EOC-Providence VAMC Fire and Fire/Smoke Damper Failed Report

EOC-PROVIDENCE VAMC FIRE AND FIRE/SMOKE DAMPER FAILED REPORT

03/04/15

Damper Inspection E-Wing / 6th Floor (6) -

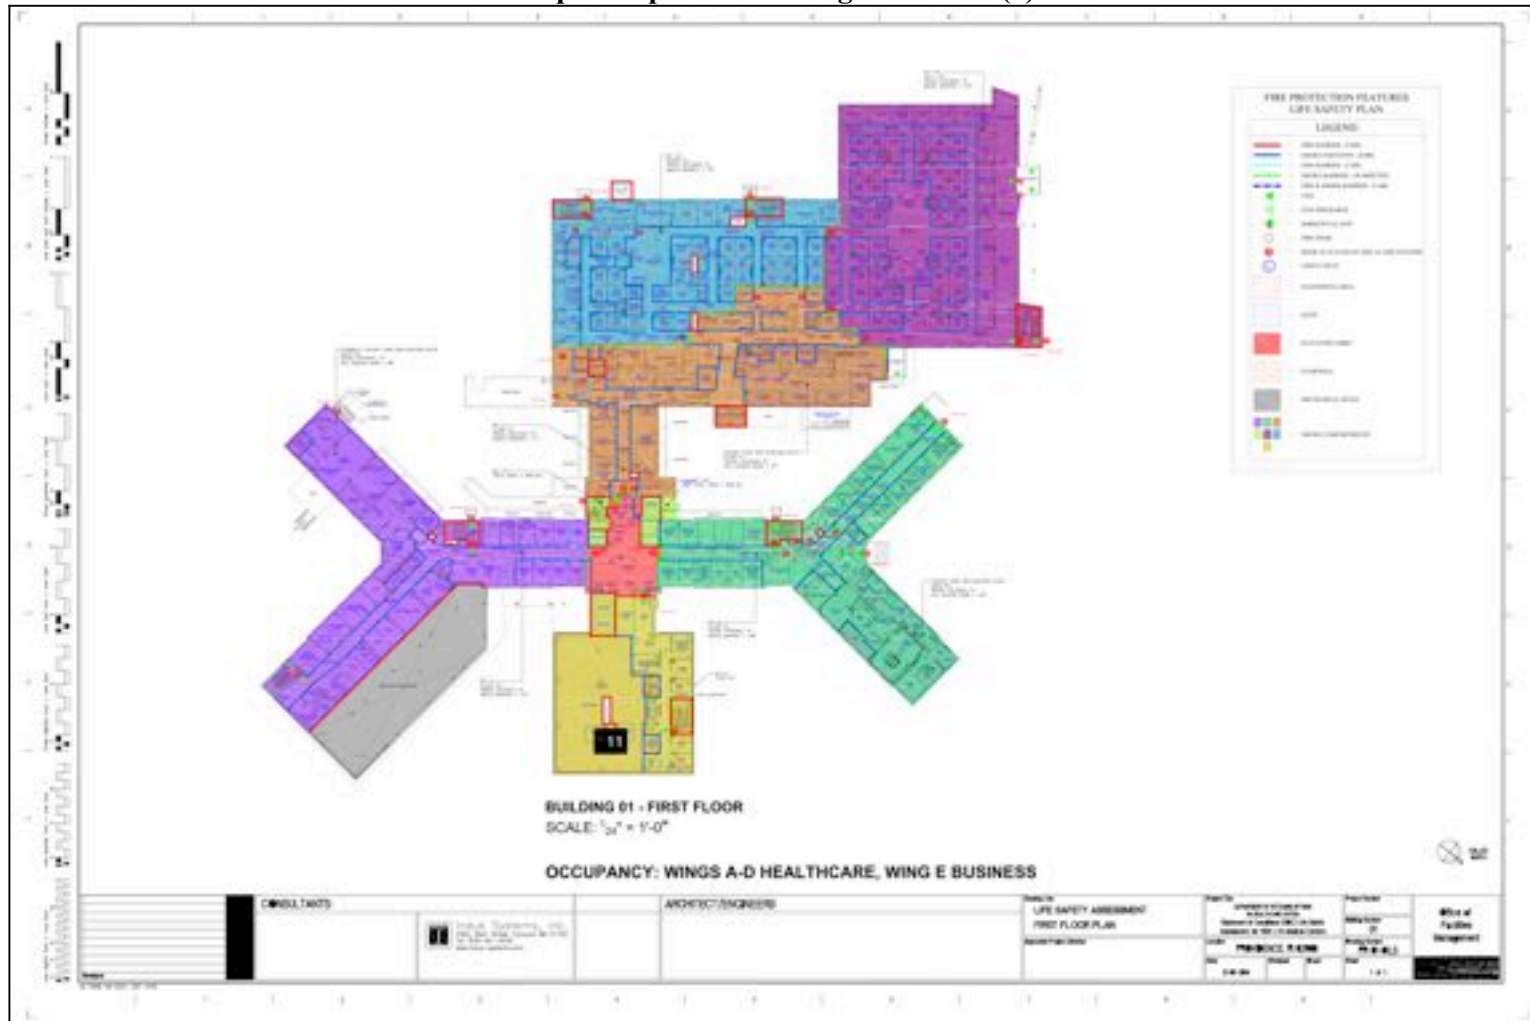
Date Created	Damper Asset Tag #	Damper Size	EOC ID #	Punch #	Type	Floor	Comments
1/13/15	FSD-016E61	14x12	211836	2	Smoke/Fire damper	6th Floor	Damper Failed. No visible access. Actuator appears to be functioning properly, air flow stops which indicates that the damper is closing, but no visible access. Access door needs to be moved to gain visible access.
1/13/15	FSD-016E60	16x8	211837	3	Smoke/Fire damper	6th Floor	Damper Failed. No visible access. Actuator appears to be functioning properly, air flow stops which indicates that the damper is closing, but no visible access. Access door needs to be moved to gain visible access.

Damper Inspection E-Wing / 1st Floor (1) -

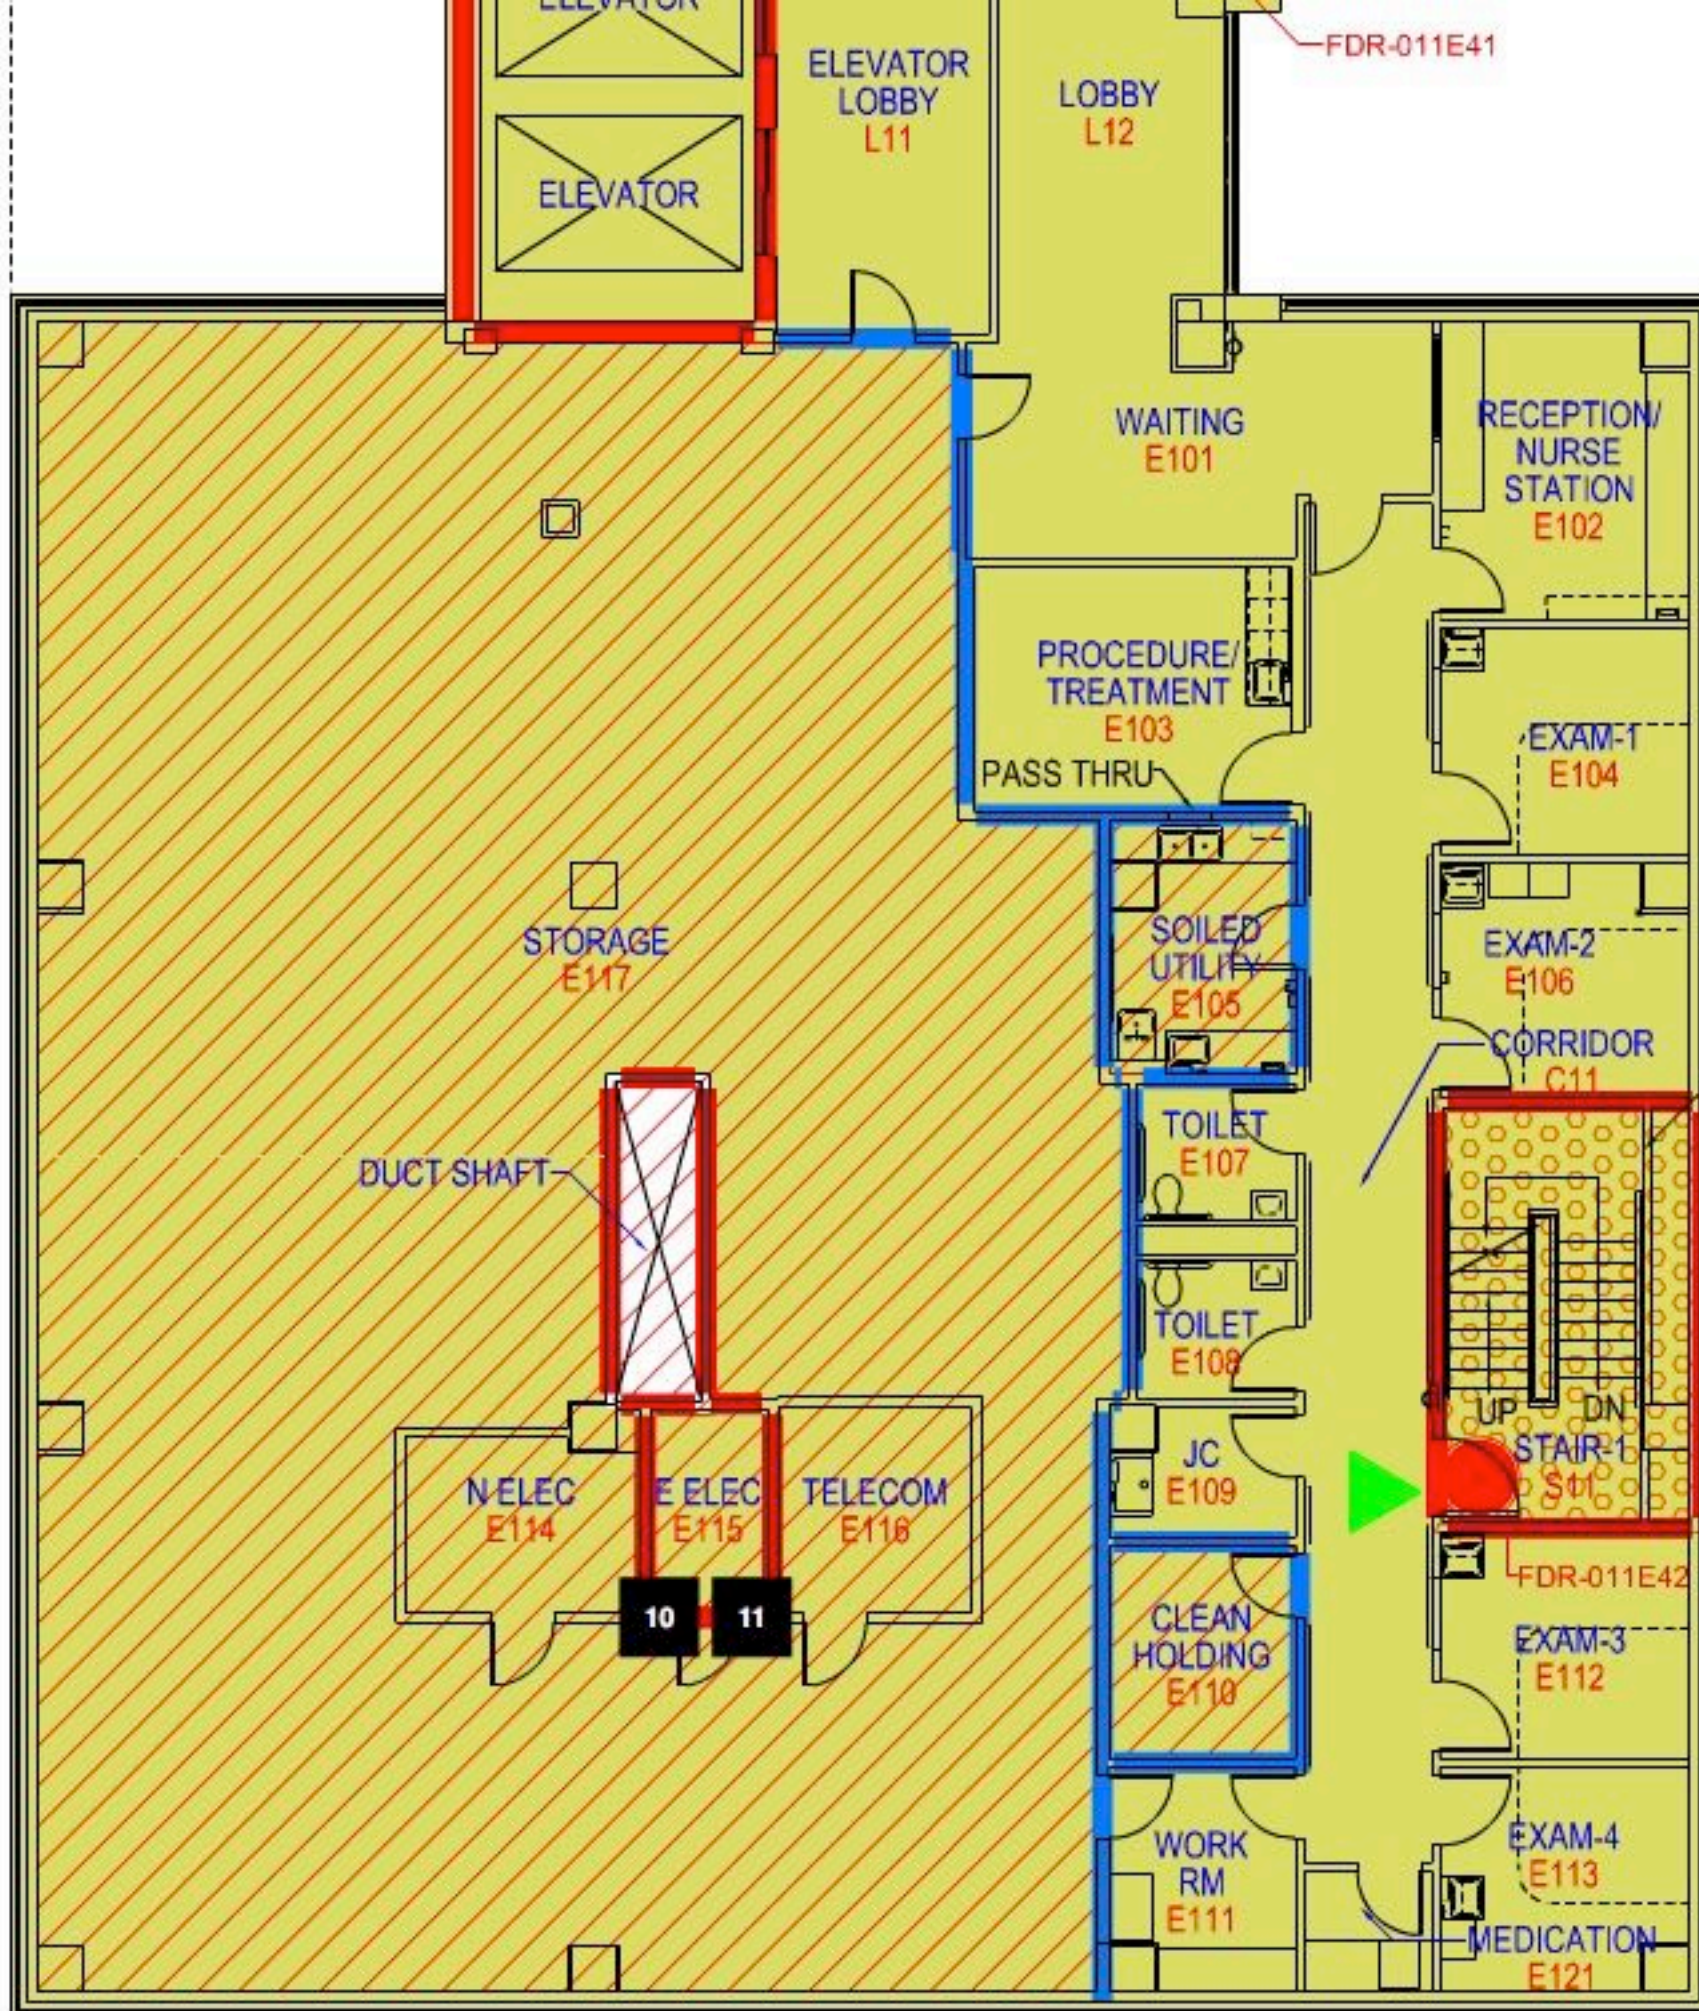
Date Created	Damper Asset Tag #	Damper Size	EOC ID #	Punch #	Type	Floor	Comments
1/13/15	FD-011E165	8x6	211811	10	Fire Damper	1st Floor	Damper Failed. Damper was damaged during installation and was not installed in the plane of the barrier. Reference: NFPA 80 2013 Section 19.2.1.1.1 A damper installed in a fire resistance-rated assembly shall be located (in its sleeve) within the plane of the fire resistance-rated assembly, unless listed otherwise and installed in accordance with the manufacturer's installation instructions and the listing.
 <p>1/13/15 11:15 AM</p>

Date Created	Damper Asset Tag #	Damper Size	EOC ID #	Punch #	Type	Floor	Comments
1/13/15	FD-011E164	6x6	211812	11	Fire Damper	1st Floor	Damper Failed. Damper was damaged during installation and was not installed in the plane of the barrier. Reference: NFPA 80 2013 Section 19.2.1.1.1 A damper installed in a fire resistance-rated assembly shall be located (in its sleeve) within the plane of the fire resistance-rated assembly, unless listed otherwise and installed in accordance with the manufacturer's installation instructions and the listing.
 <p>1/13/15 11:19 AM</p>

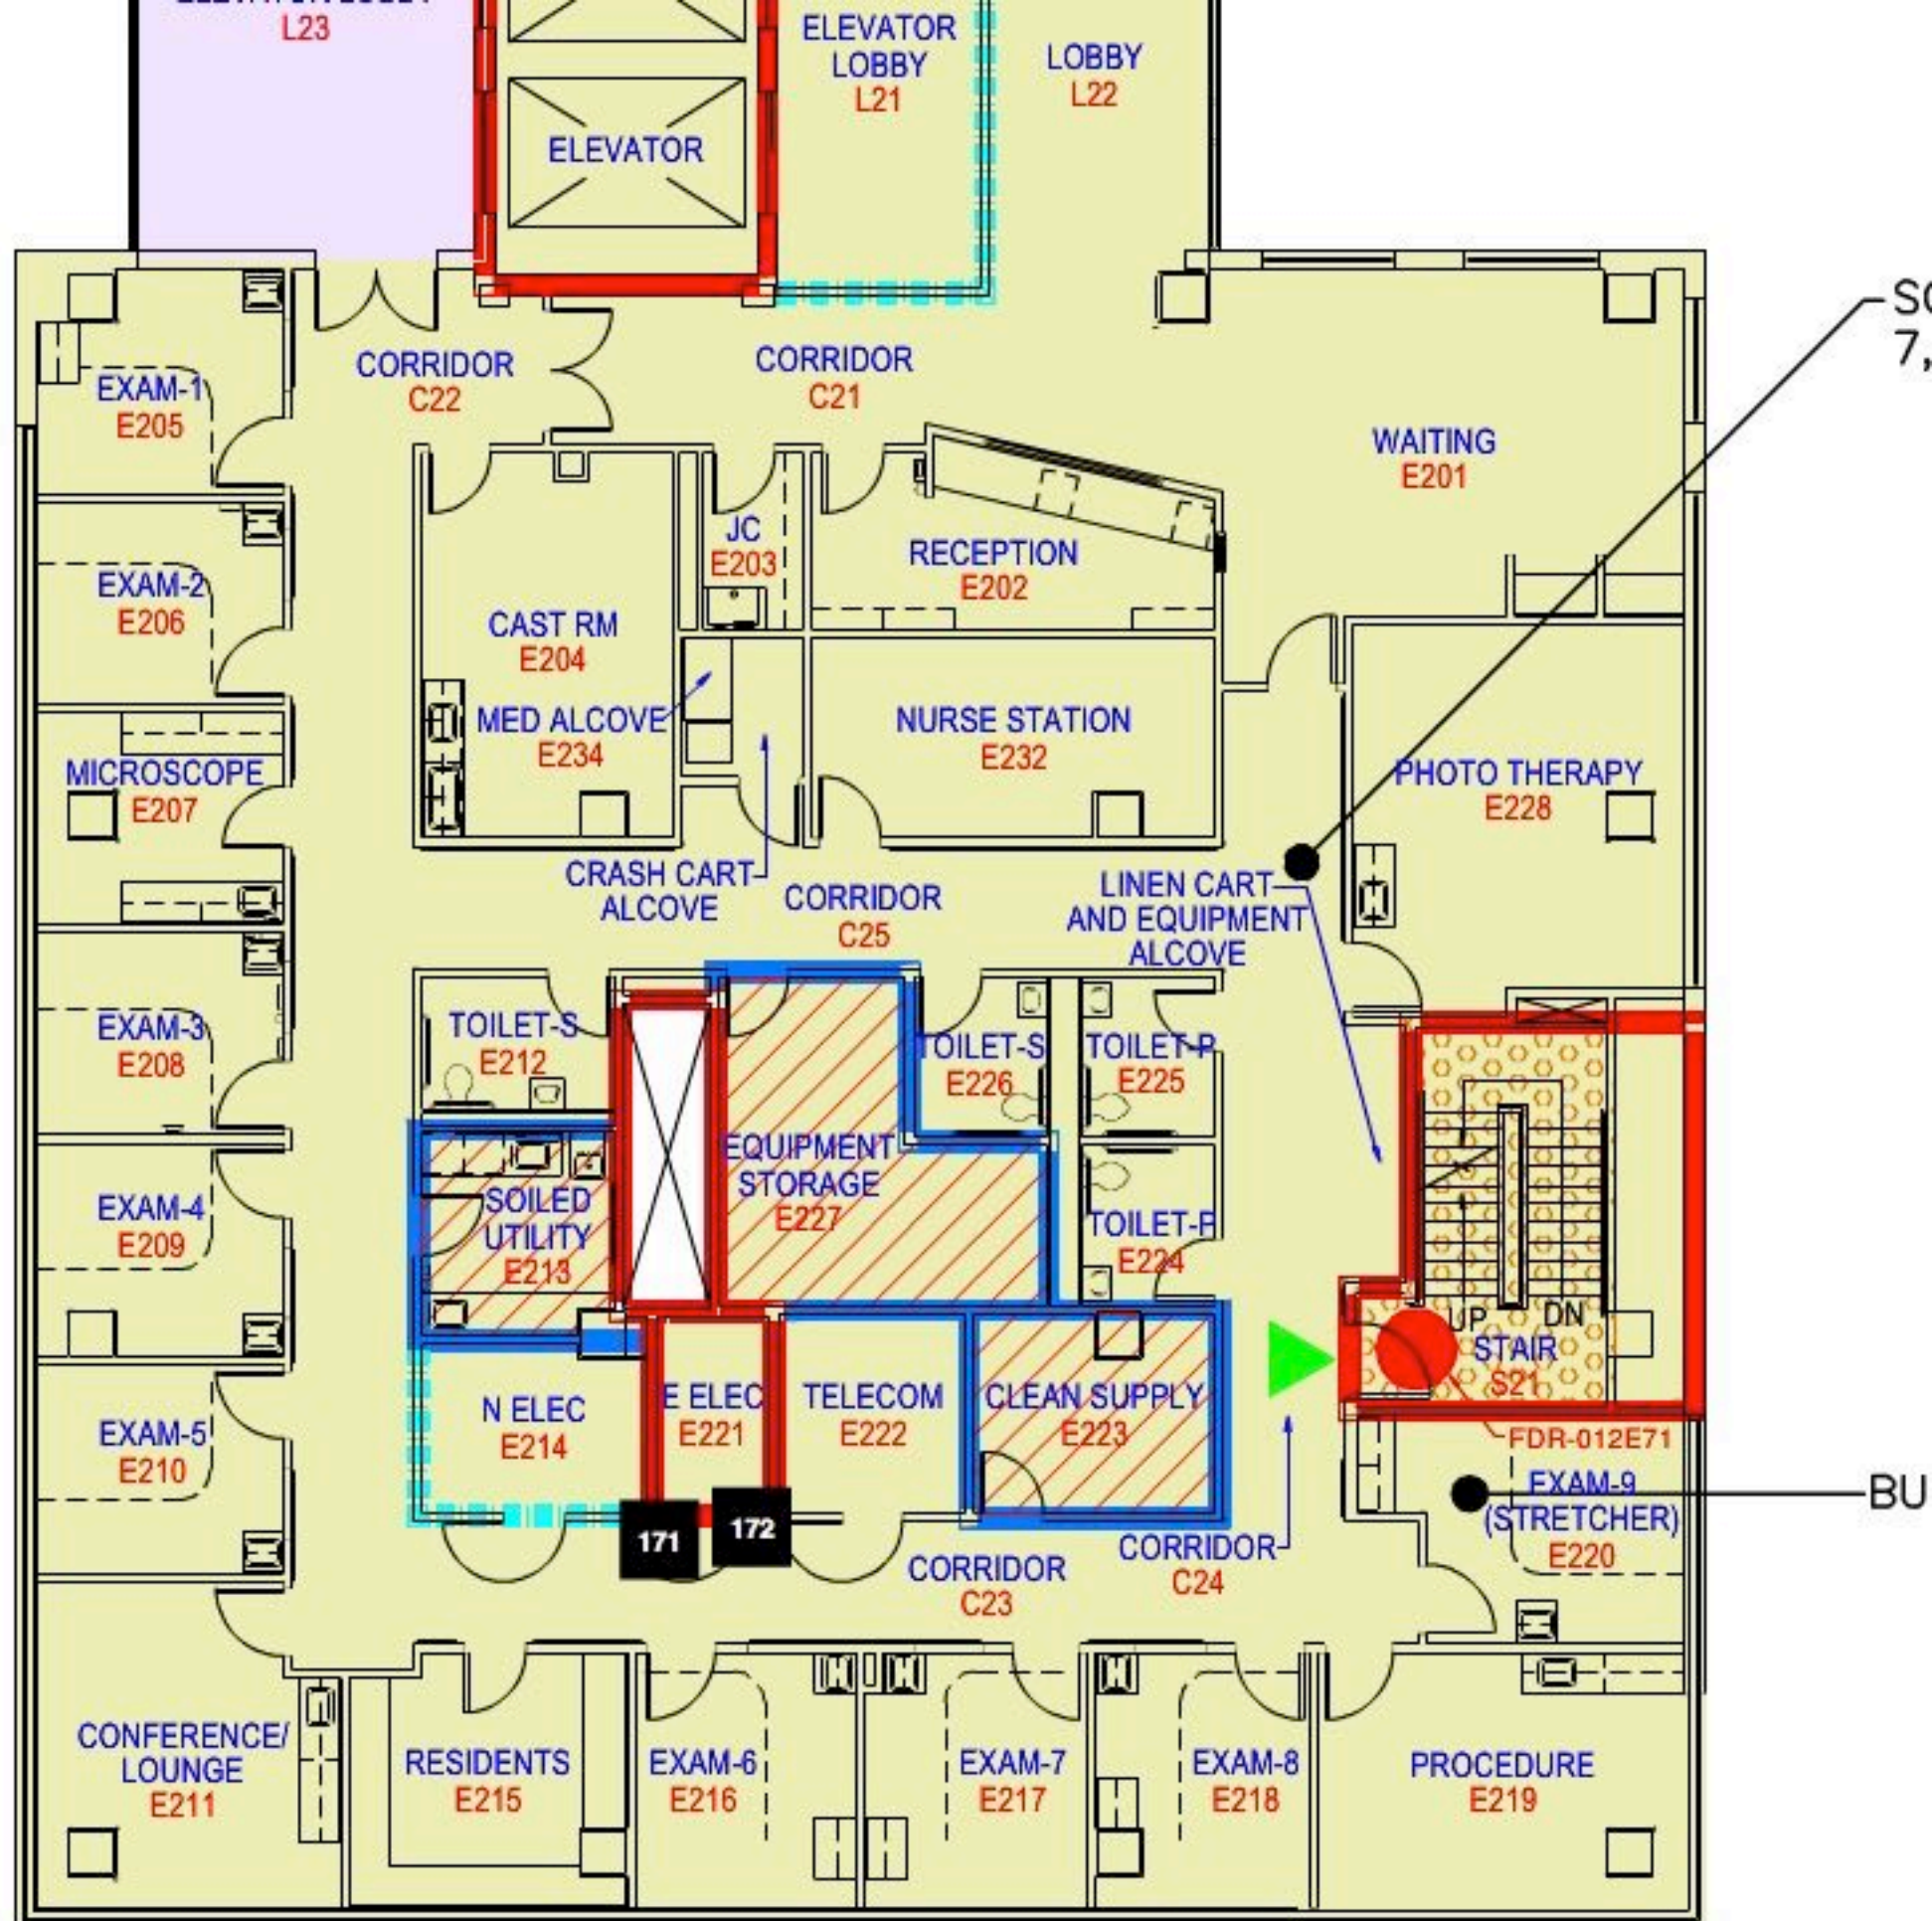
Date Created	Damper Asset Tag #	Damper Size	EOC ID #	Punch #	Type	Floor	Comments
1/13/15	FD-012E167	8x6	211813	171	Fire Damper	2nd Floor	Damper Failed. Damper was damaged during installation and was not installed in the plane of the barrier. Reference: NFPA 80 2013 Section 19.2.1.1.1 A damper installed in a fire resistance-rated assembly shall be located (in its sleeve) within the plane of the fire resistance-rated assembly, unless listed otherwise and installed in accordance with the manufacturer's installation instructions and the listing.
 <p>1/13/15 11:33 AM</p>

Date Created	Damper Asset Tag #	Damper Size	EOC ID #	Punch #	Type	Floor	Comments
1/13/15	FD-012E166	6x6	211814	172	Fire Damper	2nd Floor	Damper Failed. Damper was damaged during installation and was not installed in the plane of the barrier. Reference: NFPA 80 2013 Section 19.2.1.1.1 A damper installed in a fire resistance-rated assembly shall be located (in its sleeve) within the plane of the fire resistance-rated assembly, unless listed otherwise and installed in accordance with the manufacturer's installation instructions and the listing.
